SUBJECT: Forwards Burns & Roe review of BNL comments re effects of
 desynchronization methodology used in generic & plant-unique
 chugging load specs, per Mark II owners group 820209 meeting.
 Structural responses not significant.

Subject: NUCLEAR PROJECT NO. 2
DESYNCHRONIZATION METHODOLOGY
IN CHUGGING LOAD SPECIFICATION

REVIEW OF PROF. BIENKOWSKI'S CONCERN REGARDING
EFFECTS OF DESYNCHRONIZATION ON
THE CHUGGING LOAD SPECIFICATION USED
FOR WPPSS - NUCLEAR PROJECT NO. 2

DESIGN SPECTRUM AND REQUIRED
AVERAGE SPECTRUM - 4TCO BOTTOM
CENTER (CHANNEL 28)

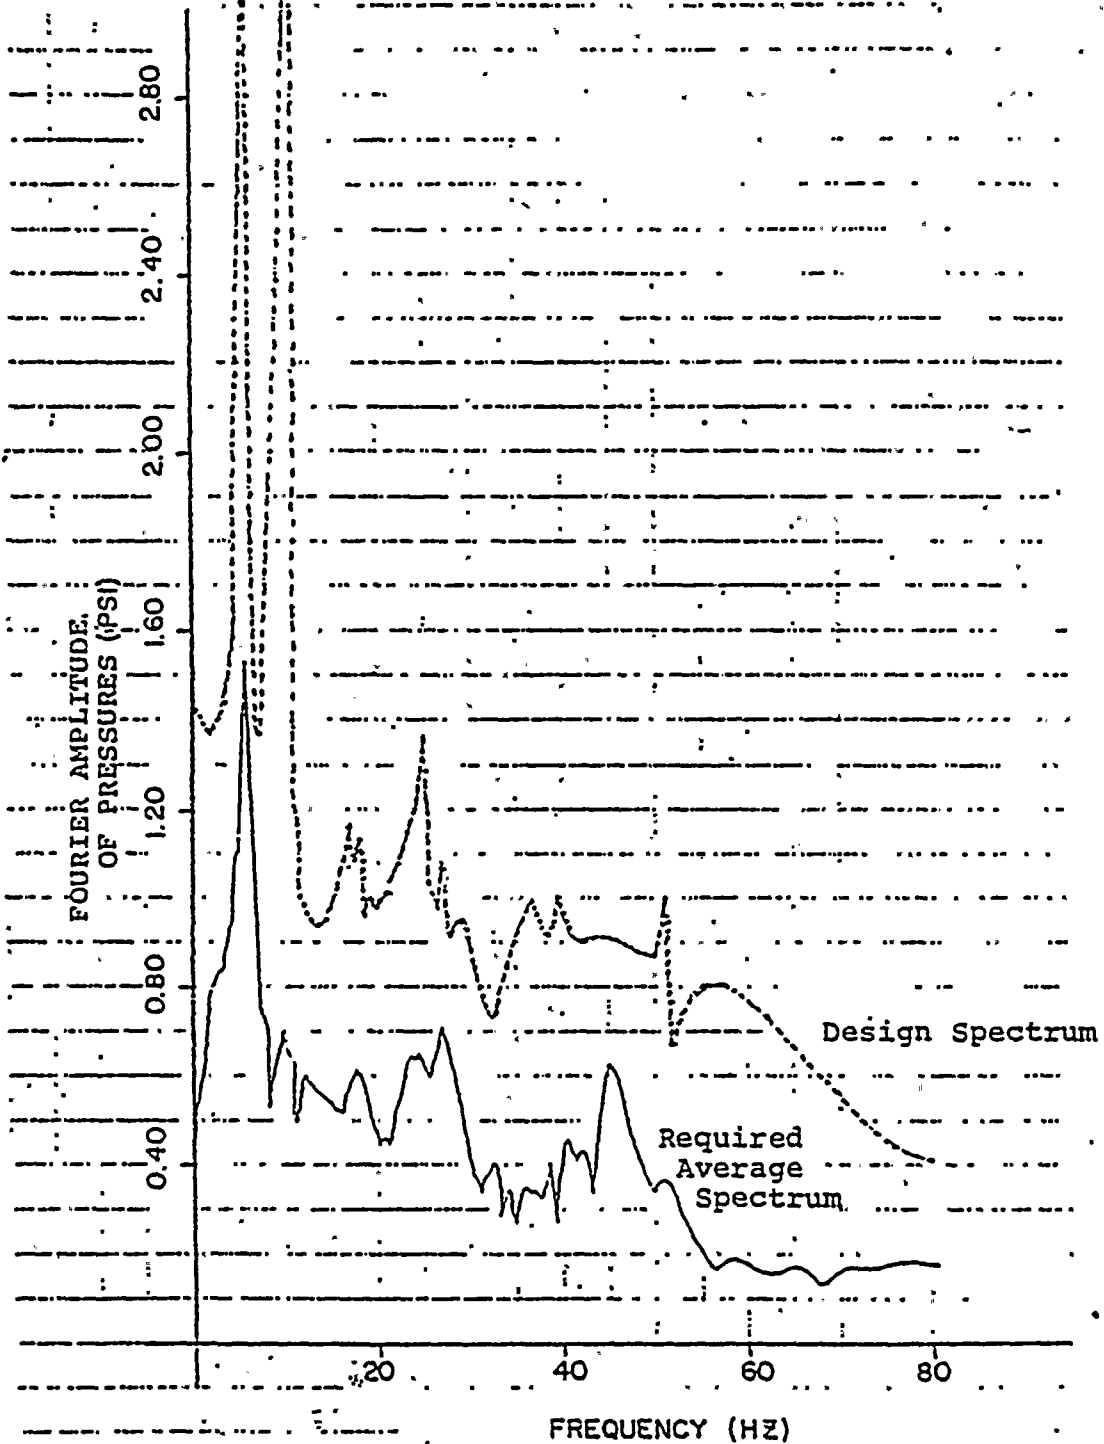
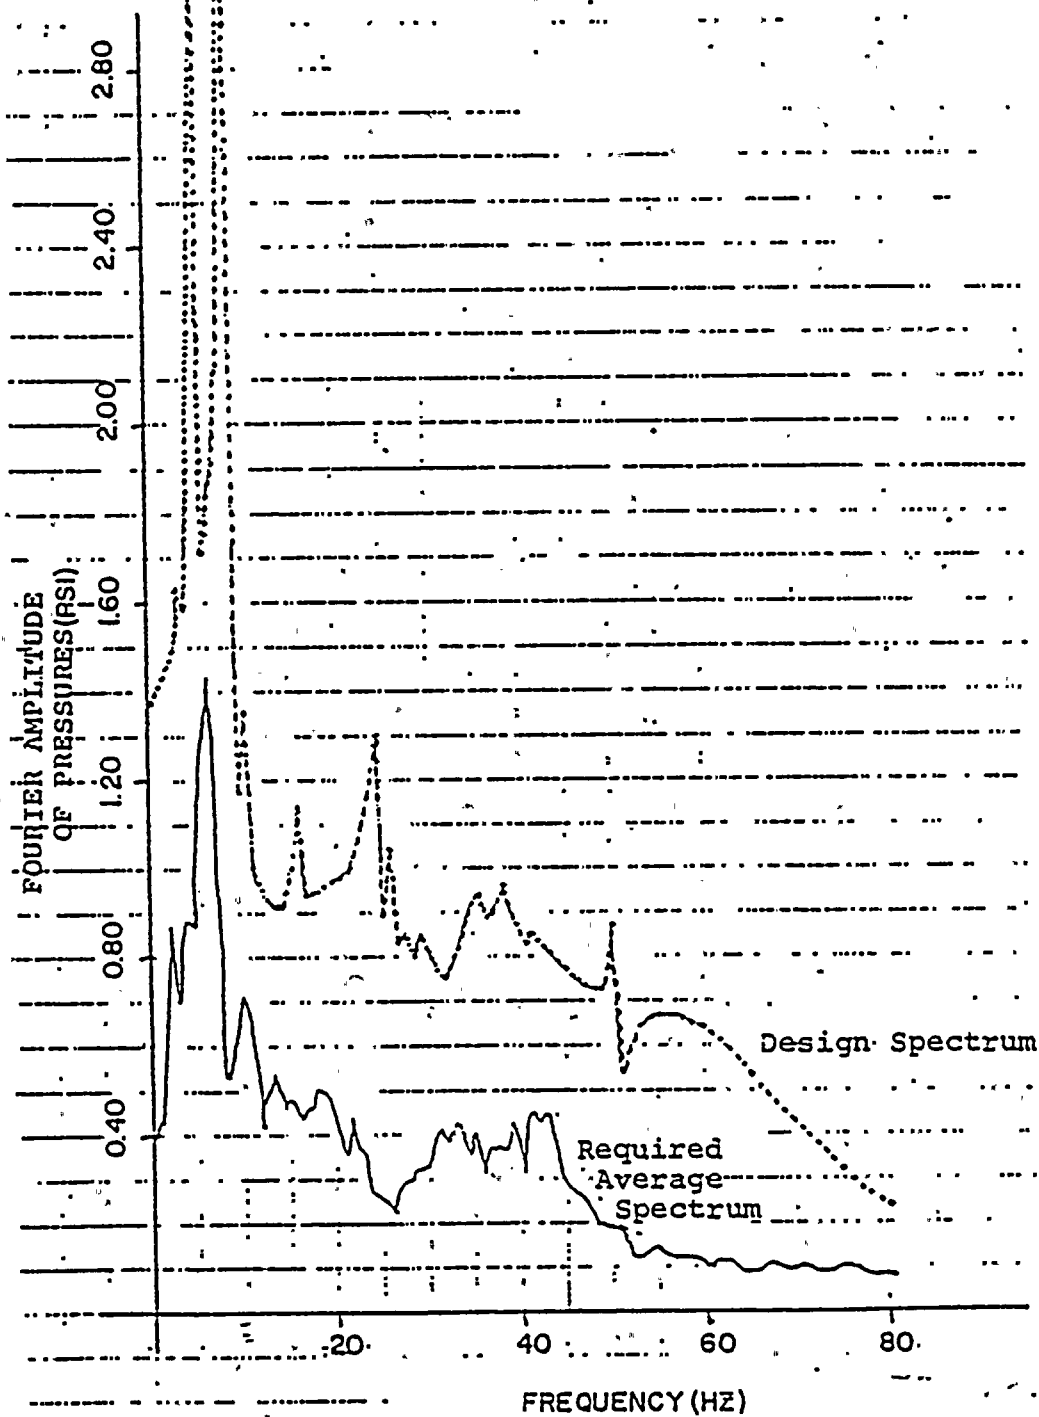
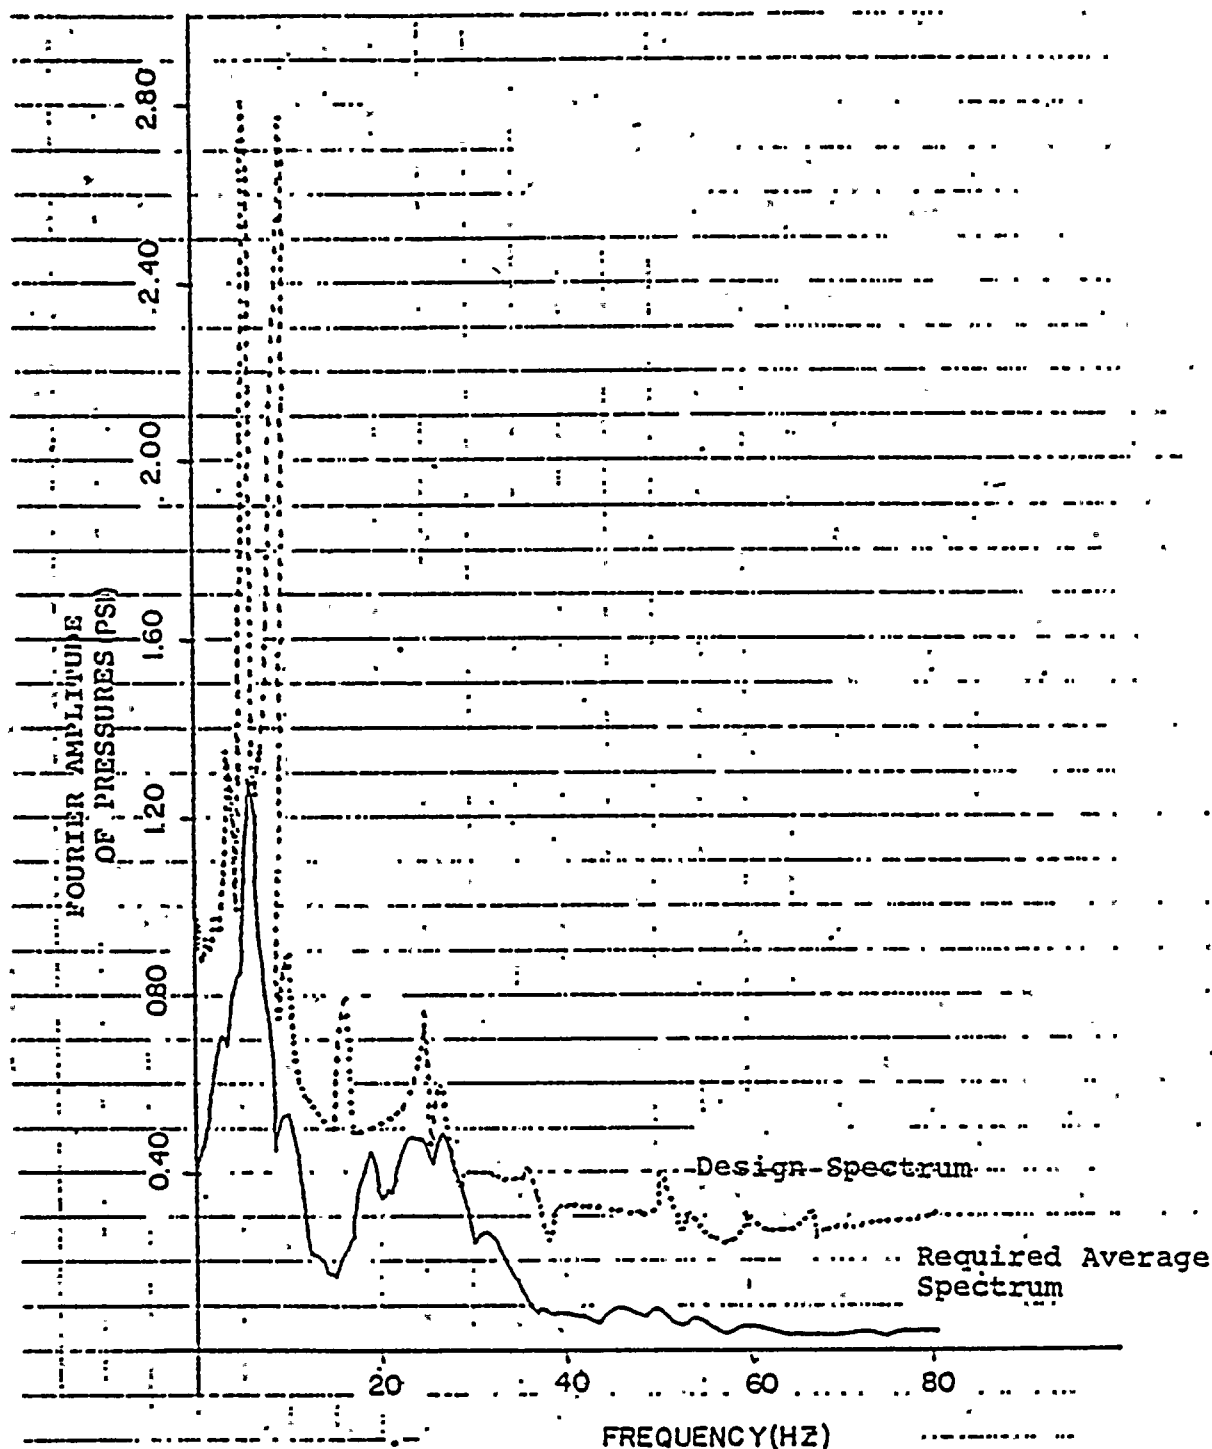
As illustrated in Figure 1, the single-vent design "source" load bounds the test data by a good margin since, as originally developed, the design load was to envelope the entire 4TCO test data base²; it was later concluded that, in view of the random nature of chugging, it is more realistic yet still adequate to bound the data base in a "statistical" sense only^{1,3}.

B. As discussed earlier in this letter-report the single-vent design "source" loads derived for application to WNP-#2 enveloped the 4TCO test data base by a good margin (see Figure 1). When this conservatism in design loads is duly accounted for, the desynchronization methodology used with the chugging load definition is shown to be adequate. Indeed, Figure 3 shows a comparison, frequency by frequency, for WNP-#2 vertical force in terms of the ratio = (PSD for-desynchronized application/PSD for synchronized application) between:

The adjusted possible design outcome values were simply obtained by multiplying the possible design outcome values estimated by Prof. Bienkowski with a factor representing the conservatism embedded in the single-vent design "source" load definition and obtained as the ratio between the "design spectrum"* and the "required average spectrum"** of Figure 1, at each frequency.

Fig. 2: MAXIMUM STRUCTURAL RESPONSE ACCELERATIONS (in g's) OF WNP-2 REACTOR BUILDING DUE TO AN INCIDENT PRESSURE ($p_0 = 1$ psi) SIMULATING OVERTURNING MOMENT, HARMONICALLY APPLIED.

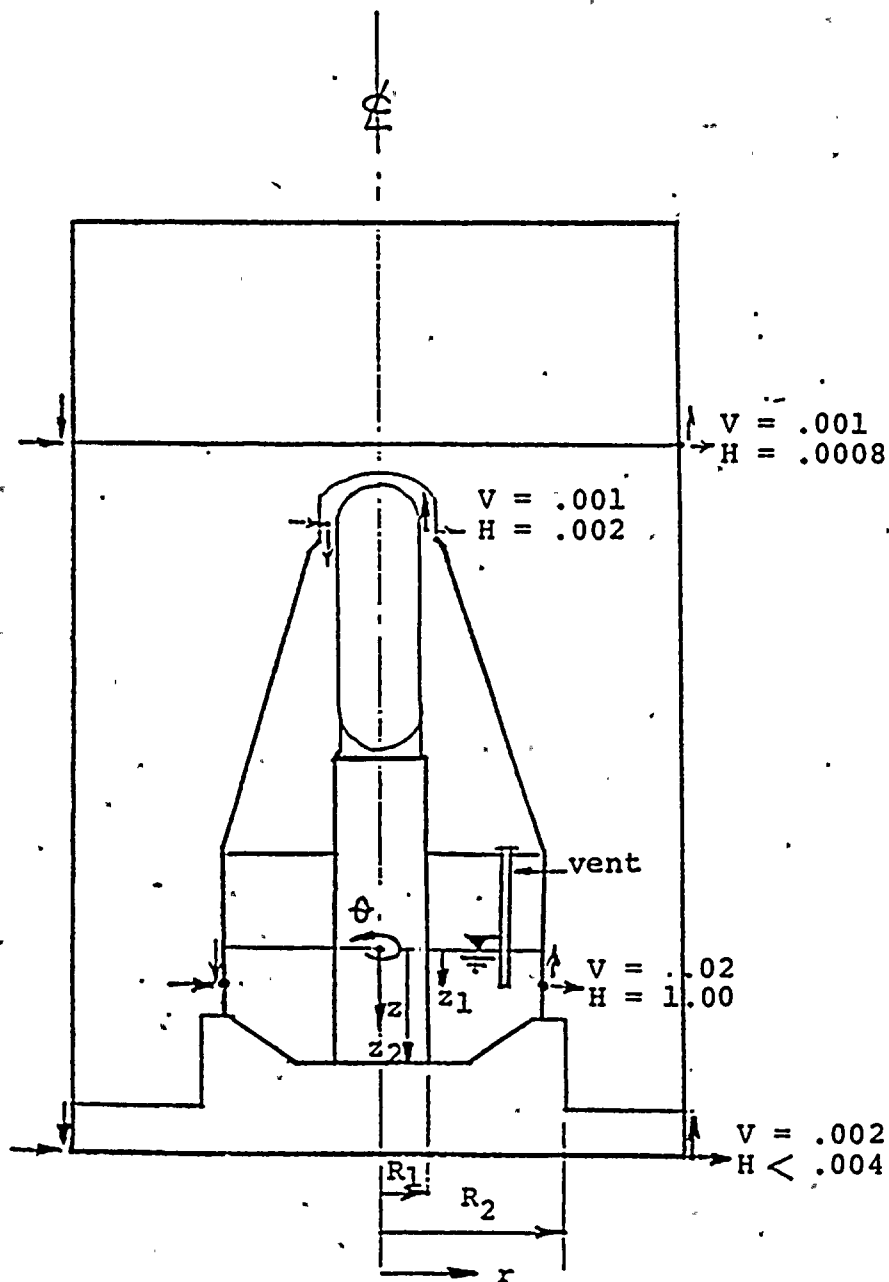
The total overturning moment on the other hand was found not to correspond to a "major" component of the structural response of WNP-#2 reactor building and thus, it cannot be viewed as a representative (or critical) parameter when assessing the chugging load specification. Indeed, the rocking of the WNP-#2 reactor building under chugging loads was found to be negligible. The analytical proof has been developed as described below. The wetted boundary of the WNP-#2 suppression pool was assumed acted upon by an incident pressure ("rigid wall" load) distributed circumferentially according to eq. (1):

thus simulating a "pure" overturning moment loading condition (for geometric notations see Figure 2). The load was assumed harmonic with the forcing frequency in the range of 0 to 60 hz varying in increments of 1 Hz. The maximum structural response accelerations calculated at different locations and corresponding to a peak pressure $p_0 = 1$ psi are displayed in Figure 2. As may be seen from Figure 2, the calculated structural responses indicate that rocking of the reactor building under the assumed "pure" overturning moment loading conditions is negligible and that responses of significance are computed only on the containment wall in the wetwell (loaded) area. Even on the basis of the unrealistically conservative assumption that the maximum calculated "rigid wall" load for WNP-#2 of 30.8 psi peak pressure (see Table 5-2 of Reference 1) is harmonic with a frequency anywhere in the range of 0 to 60 Hz and distributed according to eq. (1), the resulting maximum reactor building structural response accelerations would still be very small outside the primary containment wetted boundary.

This analytical finding should not come as a surprise; indeed, on physical grounds, significant structural responses are expected at, or in the immediate vicinity of, the applied load; furthermore, with the load applied near the foundation mat of a large and heavy structure with the geometry and inertial and stiffness properties of the WNP-#2 reactor building the soil-structure interaction modes (rocking and translational) are not likely to be excited to any significant degree. On the contrary, under seismic excitation, the WNP-#2 reactor building would respond largely in the soil-structure interaction modes, i.e., rocking and translating about the foundation material.

It is concluded, on the basis of all the above, that the vertical force may be viewed as a parameter critical for assessment of chugging loads, but not the overturning moment.
